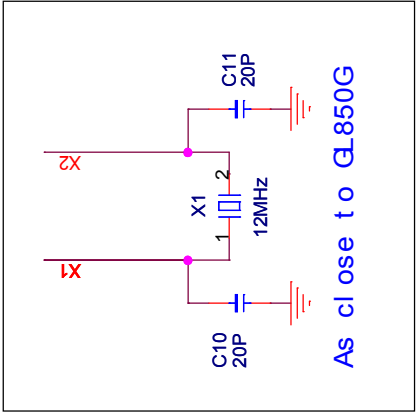
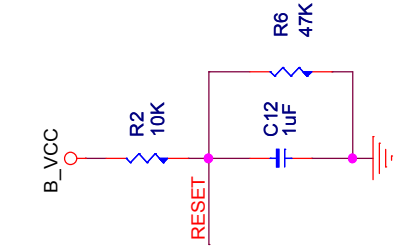
EC1 close to PIN24

As close to GL850G

GL850G-22 not support power switch

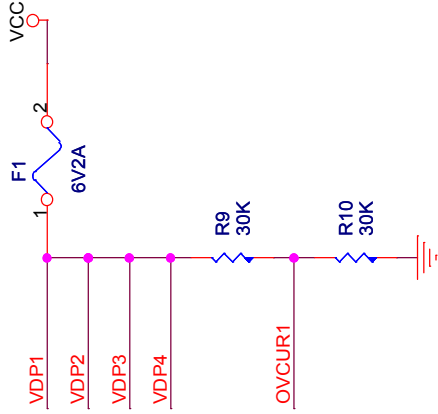
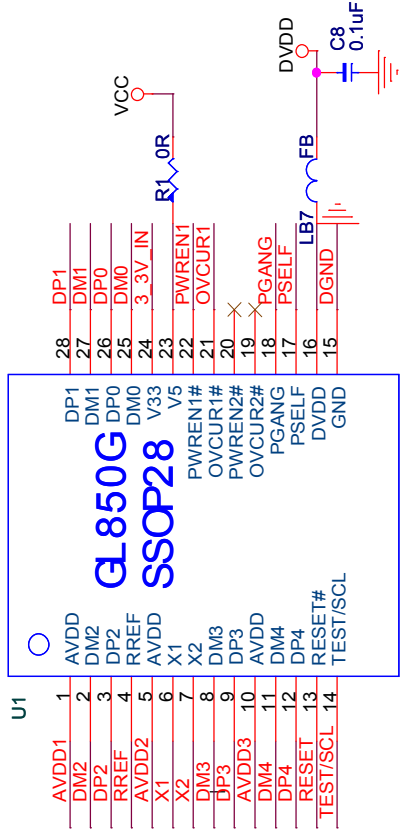
R1: Munt -> Internal regul at or
Remove -> External regul at or

Pol y Fuse for Gang Mbde
